New Jersey Transit: CAC Closeout Hardware

Issue: Charge Air Cooler (CAC) closeout getting loose.

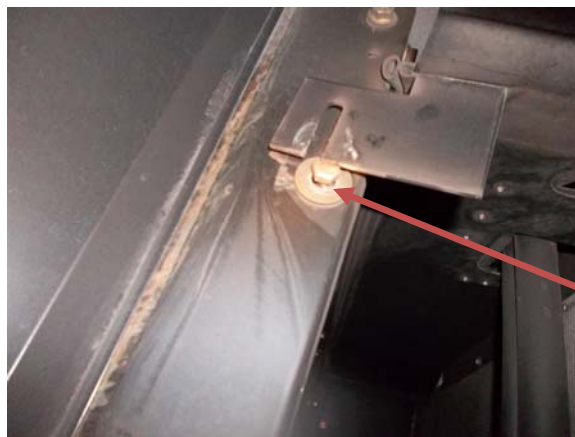
Reason/ cause: Lock washer was left off.

Add lock washer here

Solution: Add lock washer and replace closeout bracket if needed.

1. Park the bus and apply the parking brake.
2. Turn off main battery disconnect switch(es).
3. Remove the screen on the curb side at the rear of the bus.
4. Remove the bolt of the closeout panel bracket and add a lock washer. Replace bracket if broken.
